# ASSESSMENT REPORT – MIXED USE DEVELOPMENT S79C – Environmental Planning & Assessment Act 1979

DA No:	DA/540/2016
Assessment Officer:	Kate Lafferty
Property:	78-100 Church Street Parramatta Lot 100 DP 792374, Lot 504 DP 701136
Proposal:	Demolition of existing structures and construction of a 39 storey mixed use development containing ground floor commercial/retail tenancies and 398 apartments over 4 levels of basement car parking
Cost of works:	\$181,999,111
Date of receipt:	27 June 2016
Applicant:	Ecoworld c/- Think Planners Pty Ltd
Owner:	Eco World Sydney Development Pty Ltd
Submissions received:	3 submissions received
Property owned by a Council employee or Councillor:	No
Political donations/gifts disclosed:	No
Council application:	No
Issues:	Access to the site - right of carriageway
Recommendation:	Deferred Commencement Consent - creation of rights of carriageway over Council owned land
Determining Authority:	The development will be determined by the Sydney West Joint Regional Planning Panel as the capital investment value exceeds \$20 million

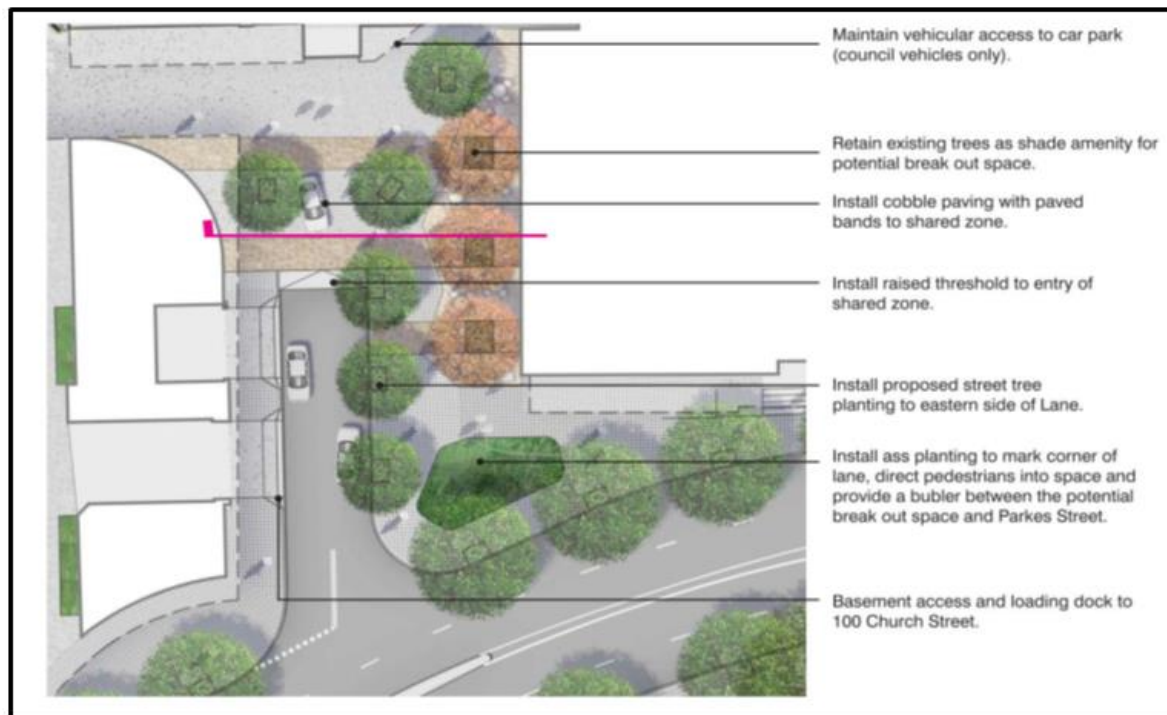
An Alignment Plan was submitted for Council's consideration. This plan indicates acceptable footpath levels and gradients for the proposed development. Council's Civil Assets Team and Urban Design Team have reviewed and approved the Alignment Plan.

Given the importance of the pedestrian environment surrounding this site, a detailed Public Domain Plan is to be submitted to Council before the issue of a Construction Certificate. This requirement is contained within the Recommendation section of the report.
